Colston Budd Rogers & Kafes Pty Ltd

16 December, 2020

RE: STATE SIGNIFICANT DEVELOPMENT APPLICATION FOR
PROPOSED CUSTOMER FULFILLMENT CENTRE
11-13 PERCY STREET, AUBURN

6.4m SMALL RIGID PASSING
19.0m ARTICULATED VEHICLE
SWEPT PATHS

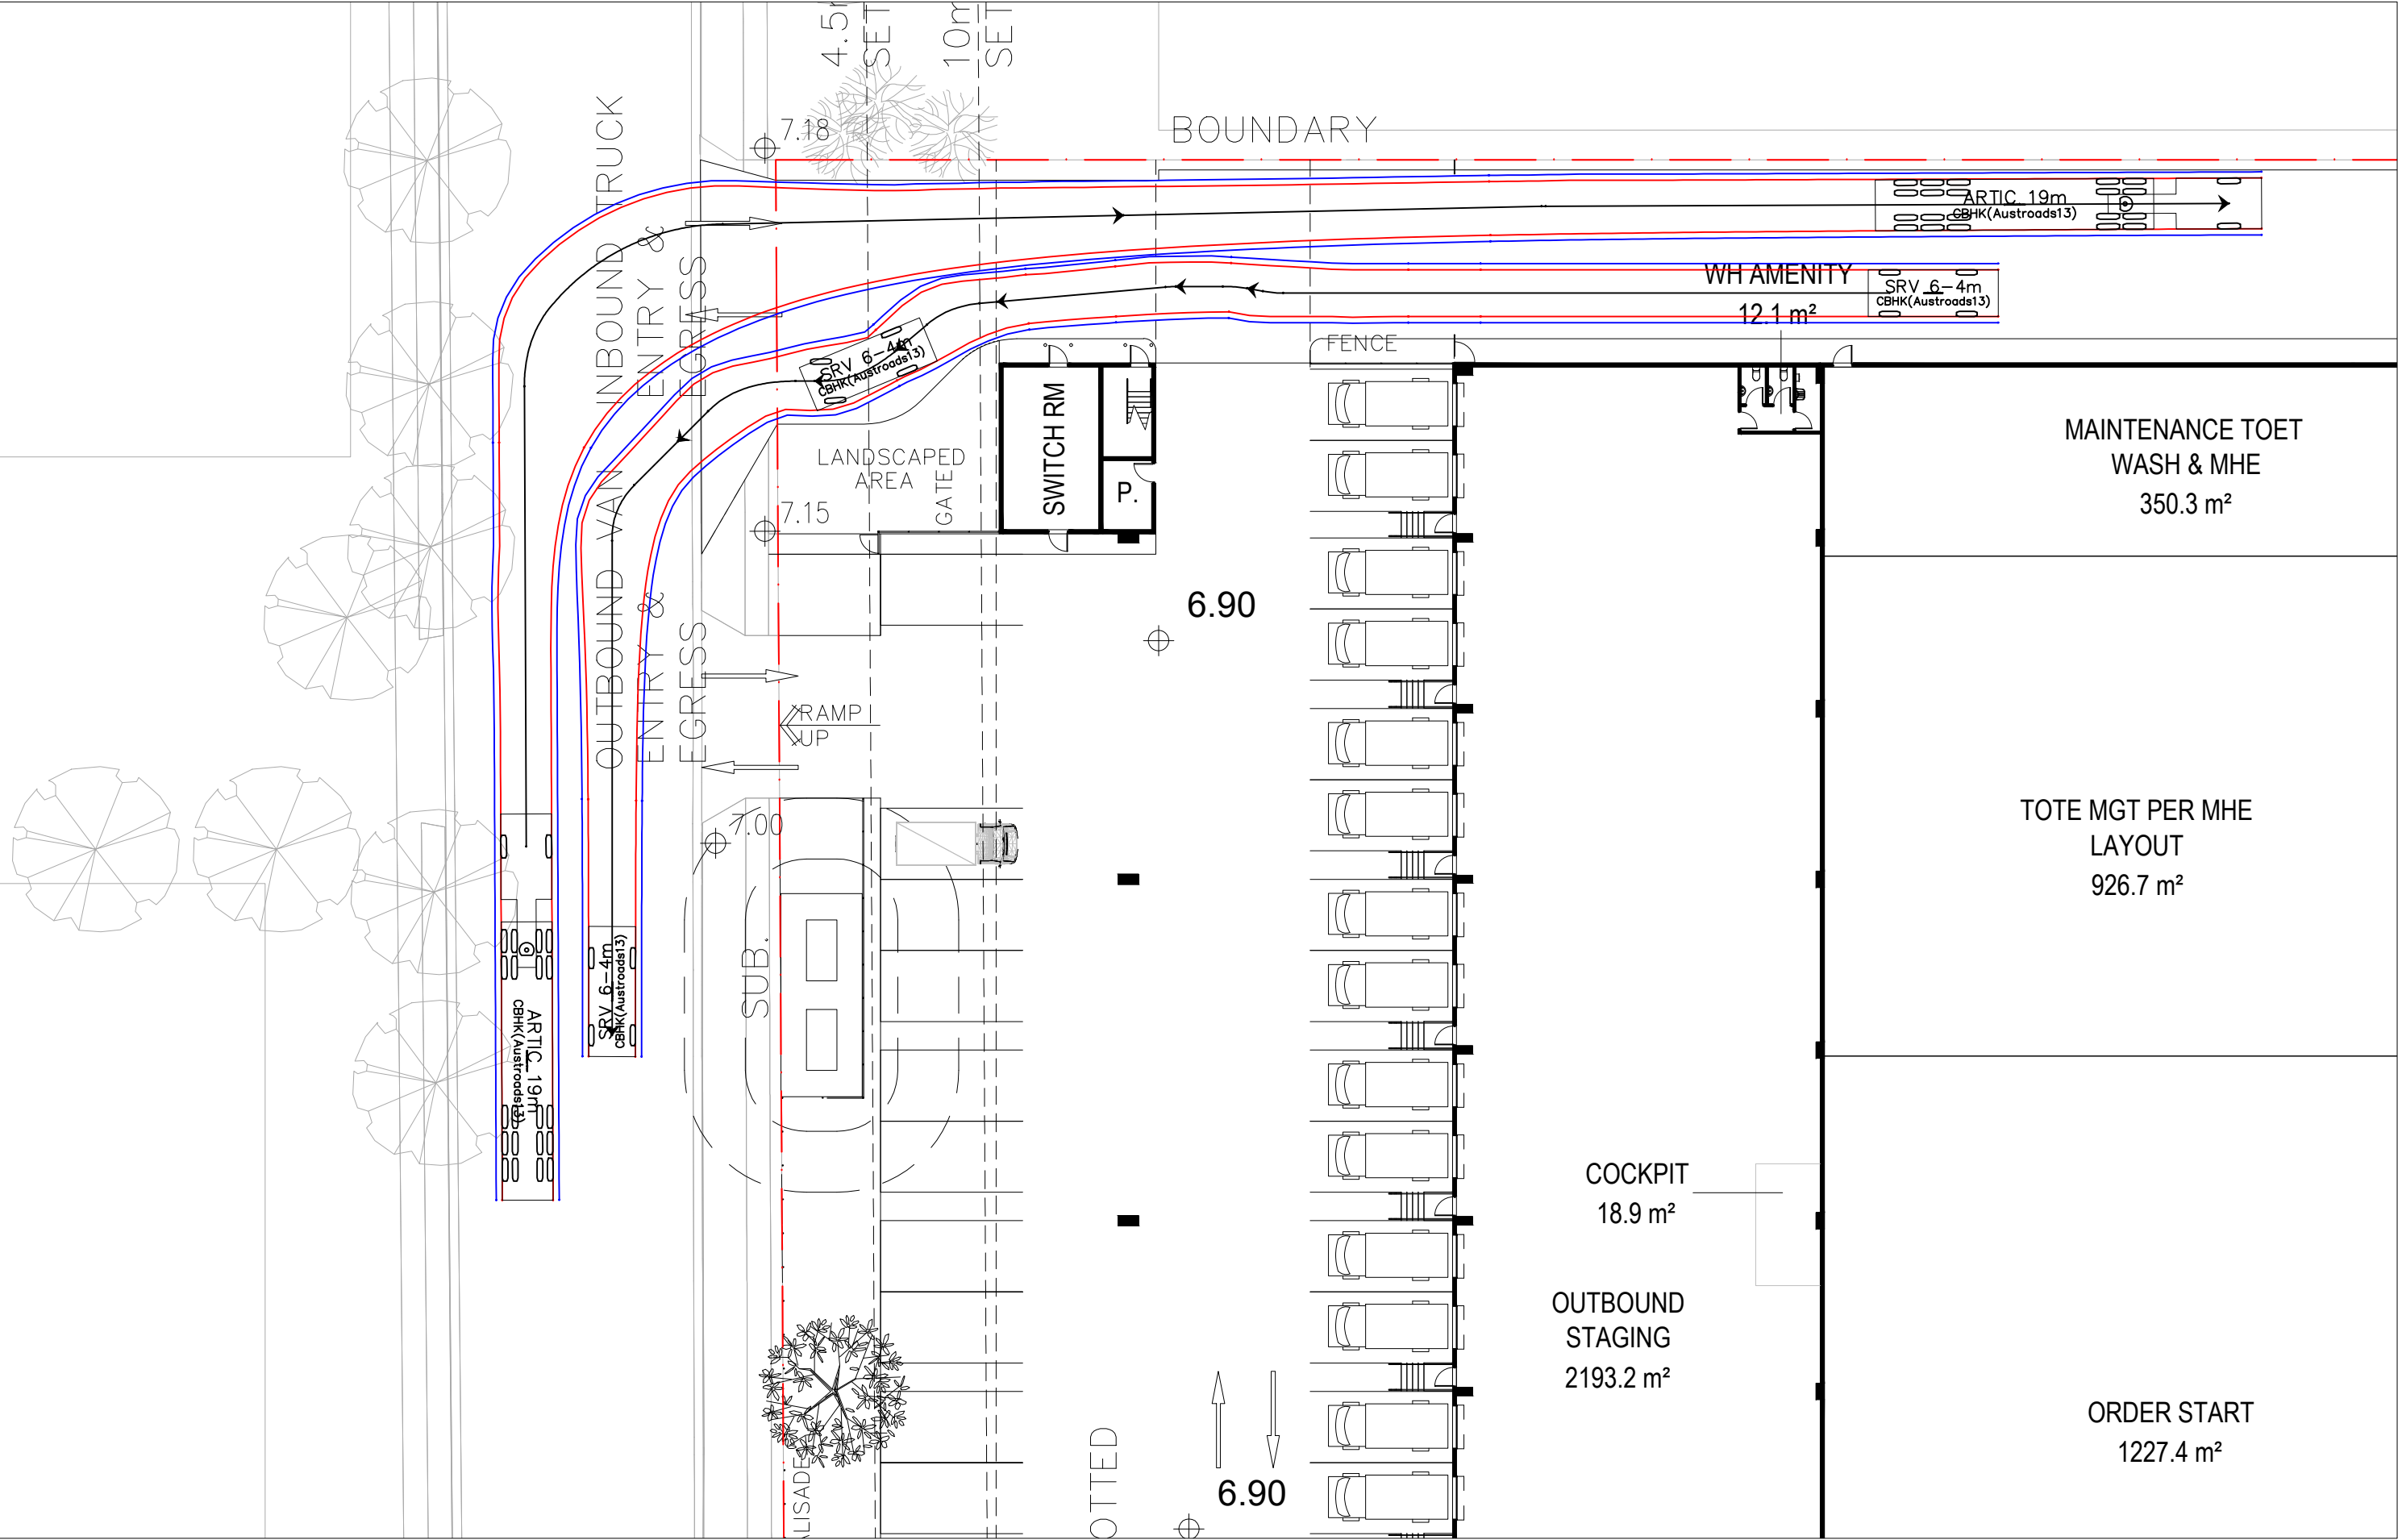
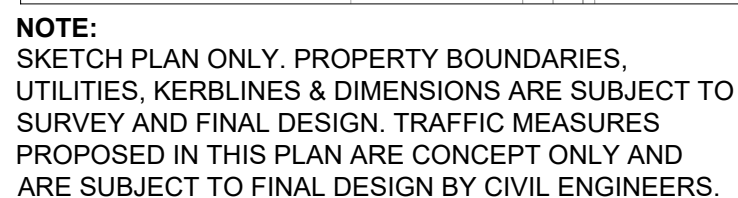
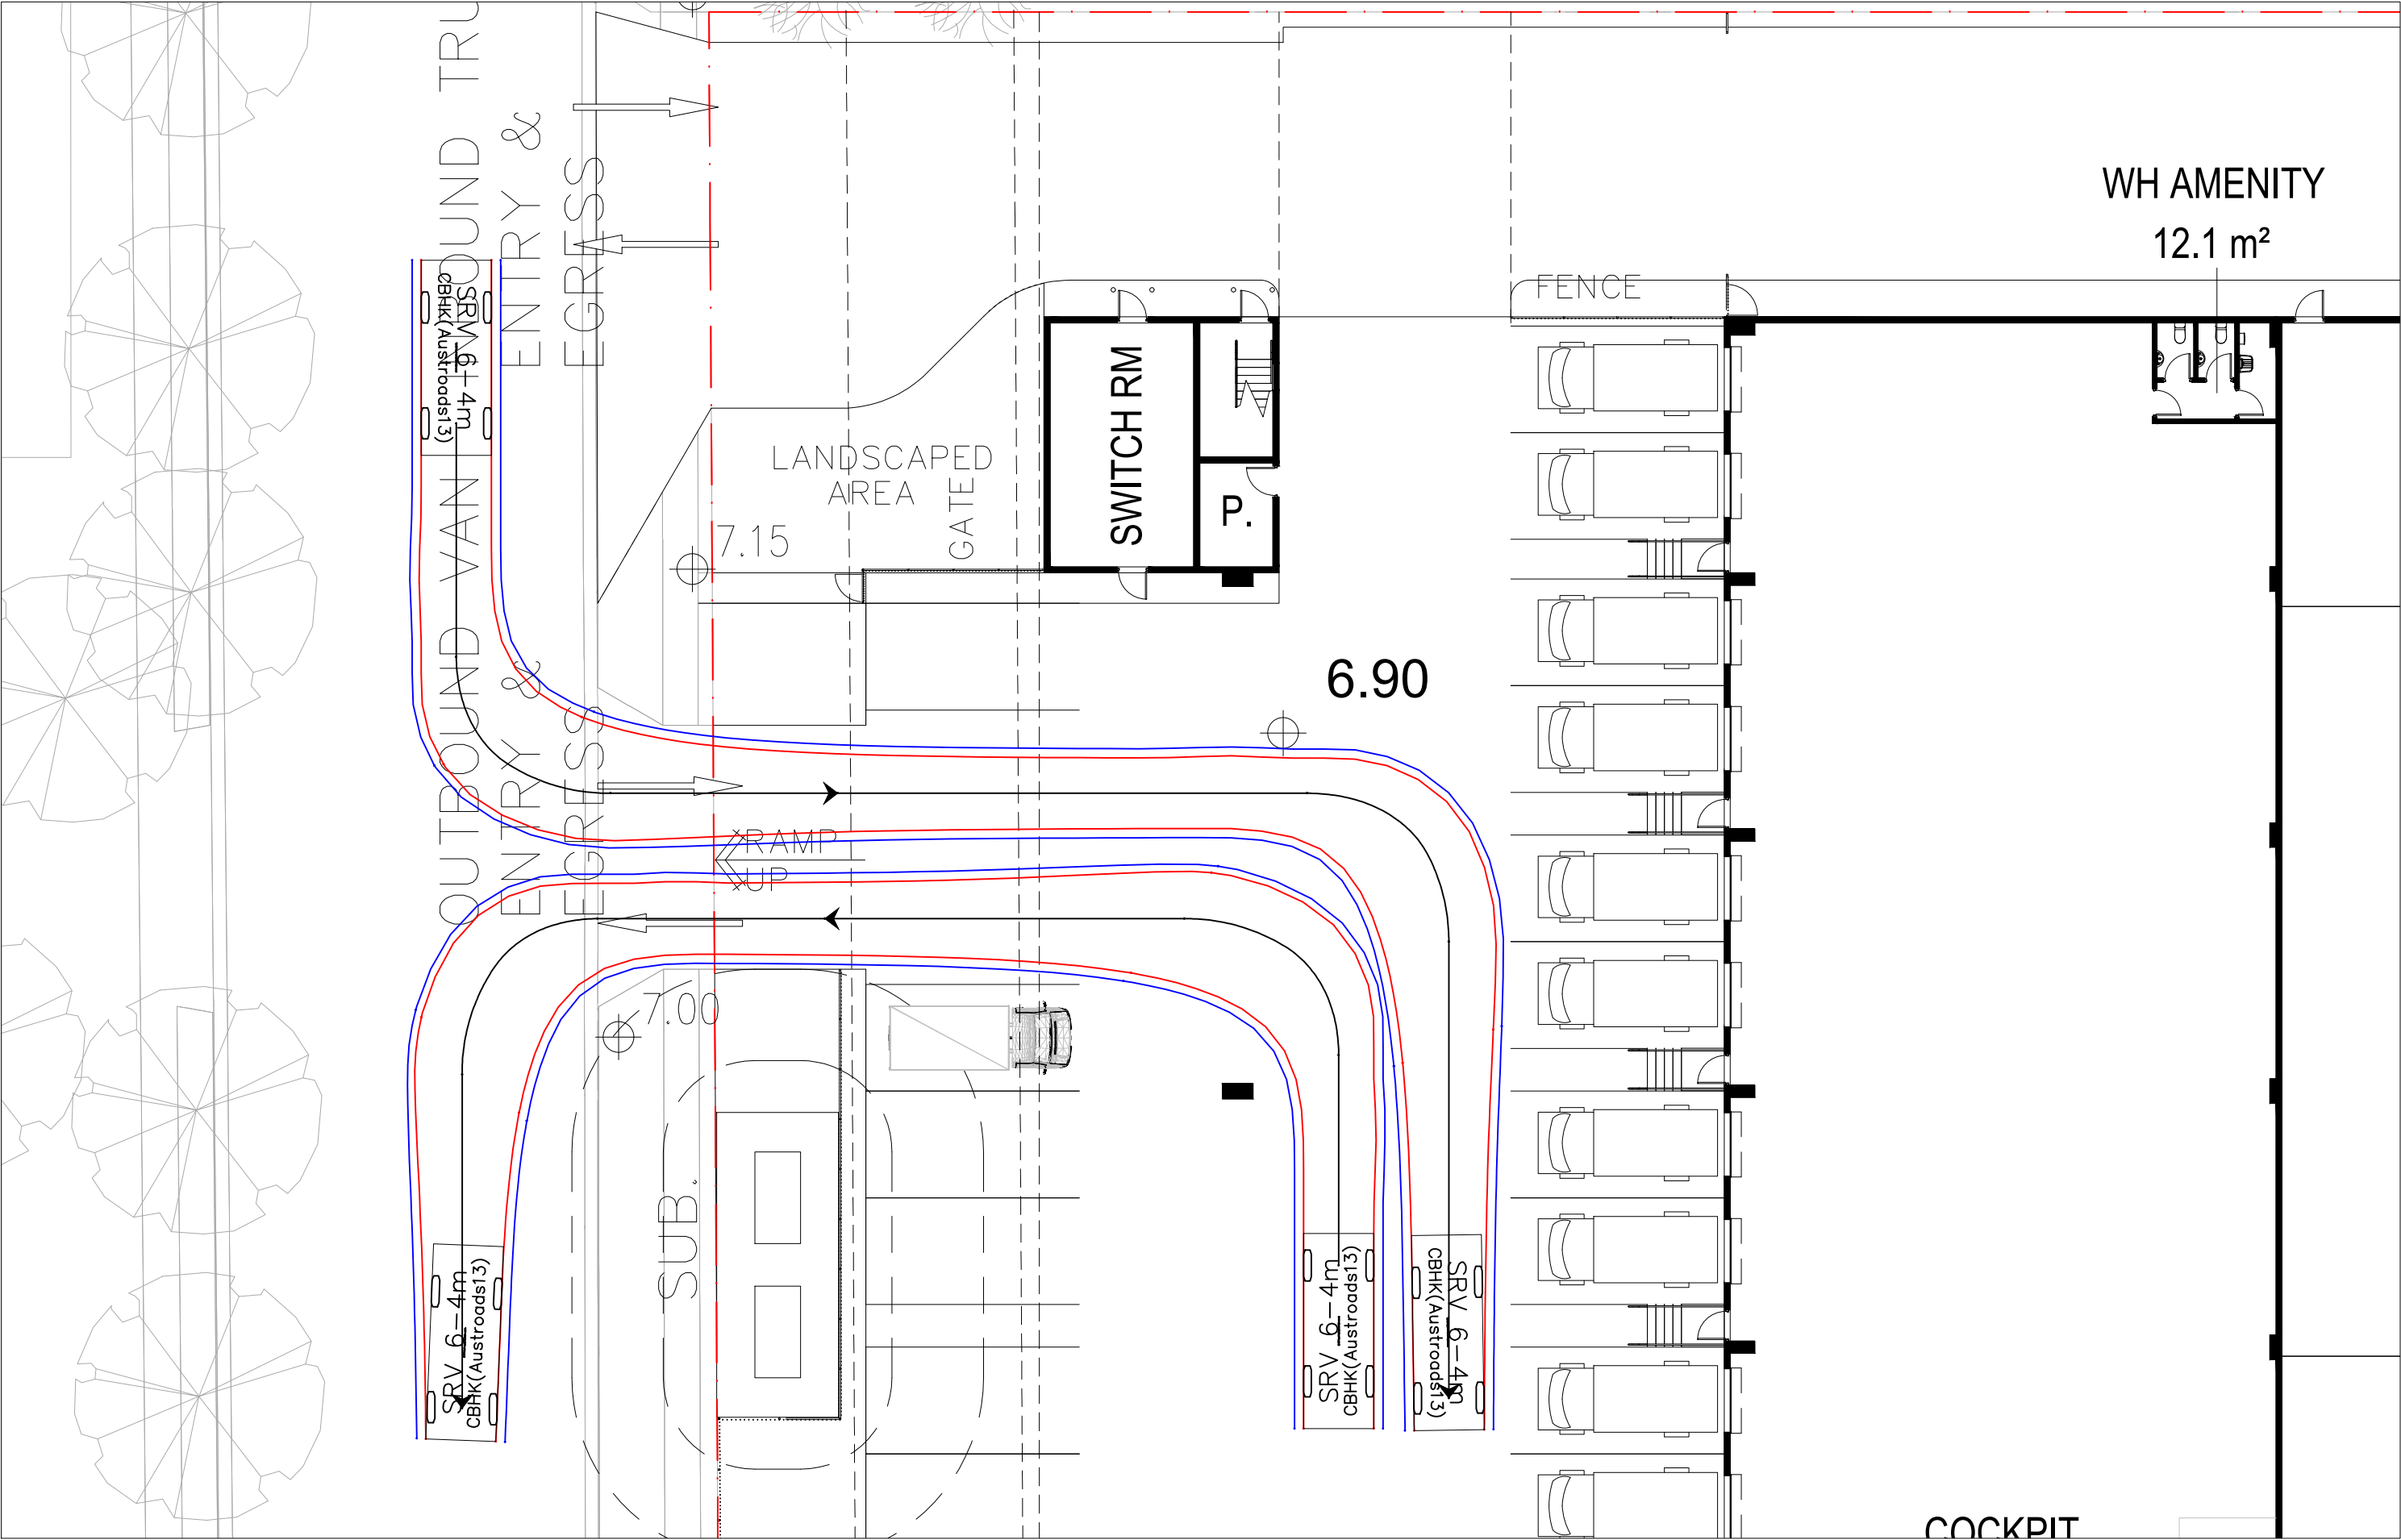
- *The left turn manoeuvring of trucks shall not encroach into the centre of the road.*
6. As shown on Figures 1 and 2, the northern driveway providing access to the inbound docks has been modified to ensure that trucks do not cross the centreline of Percy Street when exiting the site.

- *Driveway access for trucks shall be designed in such a way that trucks can pass each other within the site without queuing within the street.*
11. As shown on Figures 1 to 4, the access driveways have been modified to provide appropriate area within the site for cars and service vehicles to pass.

B99 VEHICLE SWEPT PATHS

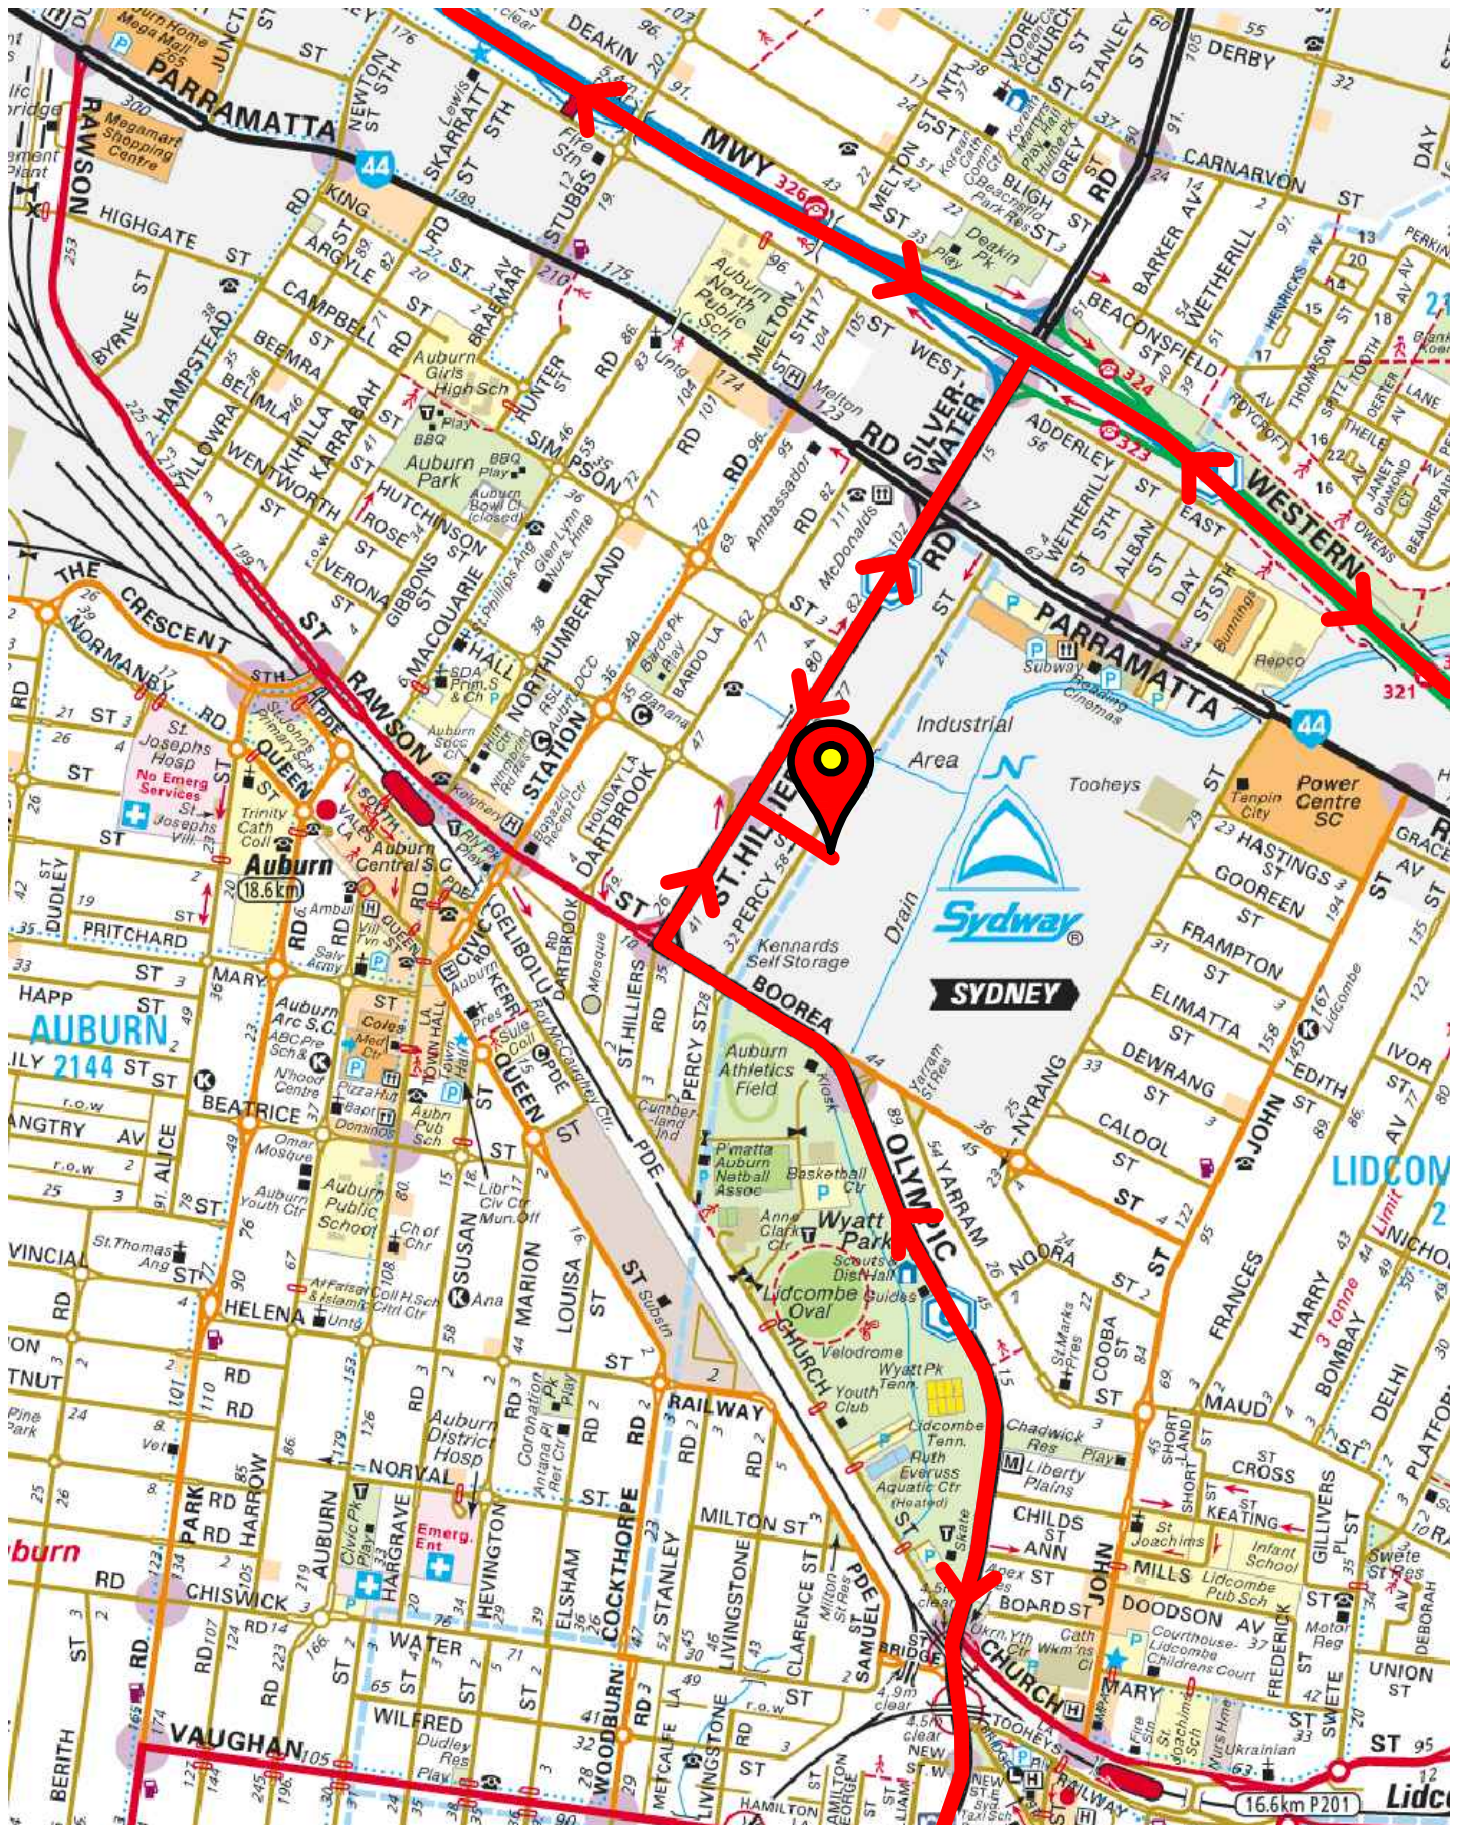
- *Please demonstrate that safe ingress/egress can be achieved by customers utilising the customer pick up facility without conflicting with truck movements.*
16. The access driveway to the customer pick-up facility has been modified as shown on Figure 5. Separate entry and exit lanes have been provided, with clear and convenient access to the pick-up bays. The proposed facility provides good sight lines for motorists and convenient circulation for vehicles to manoeuvre through the facility and to enter and exit the site in a forward direction.
17. As previously discuss, the southern driveway will provide access to the customer pick-up facility and emergency vehicle access to the to the inbound dock area, via the southern perimeter internal circulation road. The security gate to the east of the customer pick-up facility (separating the customer pick-
